Current Zoning: UC (Uptown Core)
Proposed Zoning: UC(EX) (Uptown Core, Exception)

Approximately 25.30 acres located east of West Morehead Street, north of South Mint Street, and west of South Graham Street.

Staff recommends approval of this petition.

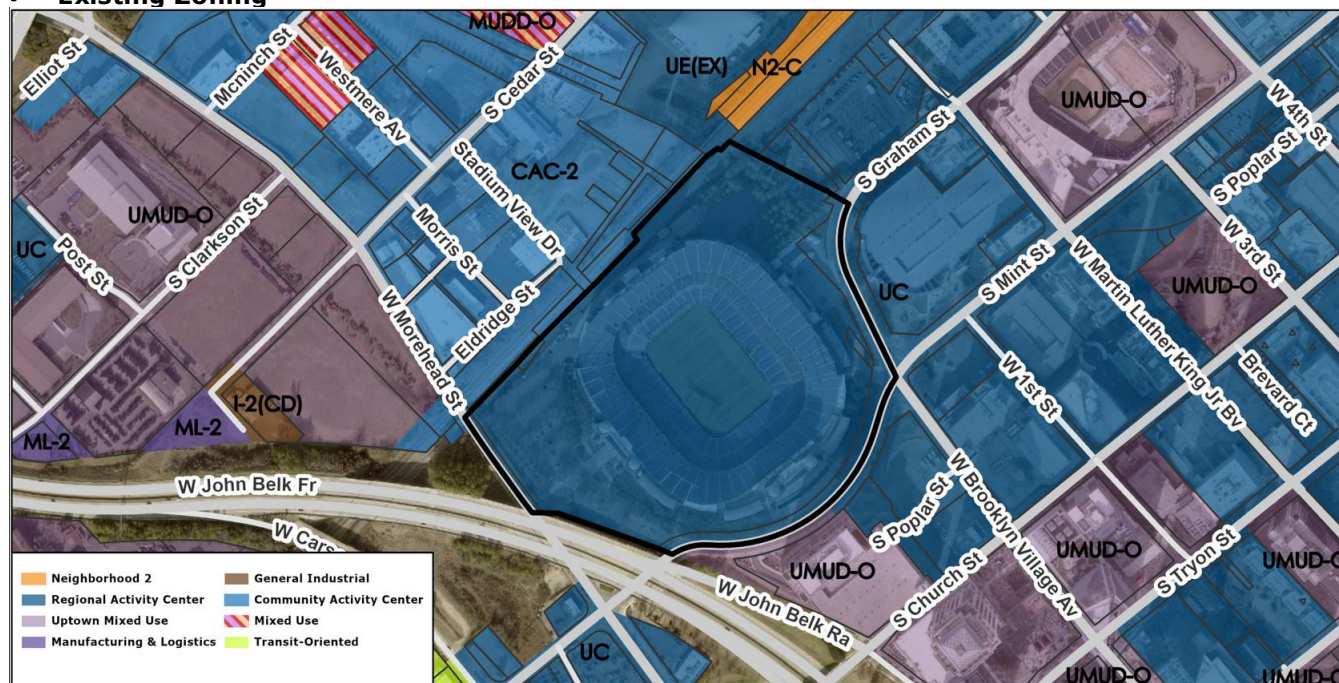
- ~~1. Conditional note 6.d. regarding improvements to South Graham Street and South Mint Street needs to be updated to state that the development will construct the required streetscape. CDOT requires clear language about it being constructed as part of this development when triggered according to ordinance requirements.~~ **Addressed**

- ~~2. Revise language for the second city improvement public benefit to wholly commit to construction of option (ii) completion of the shared use path between Graham Street and the proposed practice facility path.~~ **Addressed**

- ~~3. Provide more specific and committal language about when the city improvement benefits will be completed by.~~ **Addressed**
- ~~4. Revise site plan and conditional note(s) to commit to updating conditional note 6.e. and change triggers for streetscape to align with UDO requirements or request an EX provision to modify this standard. Streetscape upgrades are required per ordinance when triggered. Adjustments to small portions of streetscape due to topography, trees, etc. may be made during the permitting phase according to allowable exceptions.~~ **Addressed**

- ~~5. Add a conditional note specifying "the Petitioner shall dedicate and convey in fee simple all rights of way to the City before the site's first building certificate of occupancy is issued. CDOT requests rights of way set at 2' behind back of sidewalk where feasible." Conditional note 6.b. does not read clearly enough to verify the understanding that all right of way that is required by ordinance will be dedicated. Update to read exactly as shown above or update existing note(s) so that it is very clear what improvements would not have right of way dedicated.~~ **Addressed**

- ~~6. Revise public amenity language to add more detail regarding closures of the space, such as no more than 24 hours around certain events. Provide quantitative measures for how frequently per square foot elements will be placed in the open space including but not limited to seating, lighting, and plantings. Increase the minimum depth of the space from 25' to 50'. Commit to providing a public art feature within an open space area using previously provided public art feature language from UDC but with slight modifications to note that rather than the petitioner "seeking input from UDC" during the land development process regarding possible artists, the petitioner will procure the most recent list of creative pool artists from UDC. Additionally, the public art feature language should reflect that the location, type of art, and size of the art must be determined during land development processes. Clarify reasoning as to why this benefit cannot be completed earlier than May 31, 2030.~~ **Addressed**

- ~~7. Work with Urban Forestry on protecting existing trees located within the ROW since the existing curb is to remain and revise conditional notes to commit to this.~~ **Addressed**

- ~~8. Remove reference to Alternative Compliance Review Board process in note 3.b. as it is unnecessary.~~ **Addressed**
- ~~9. Add EX provisions related to exterior lighting, design of surface parking, design of bicycle parking, and design of parking structures to the EX table.~~ **Addressed**
